Product Change Notification (PCN)

Overview

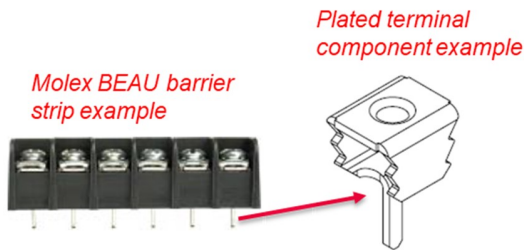
- Molex is changing the existing plating type of some BEAU barrier strip product series from Bright Tin over a Copper substrate to Matte Tin over a Nickel substrate. Matte Tin over Nickel is known in the interconnect industry of providing better resistance to plating surface oxidation while in storage as well as resistance to the Tin Whisker phenomenon.
- Product Impact
 - Product enhancement for our valued customers
 - No impact to fit, form or function"
- Part Number Impact
 - see attached impacted parts list
- Qualification Reports and samples available upon request after the date shown above
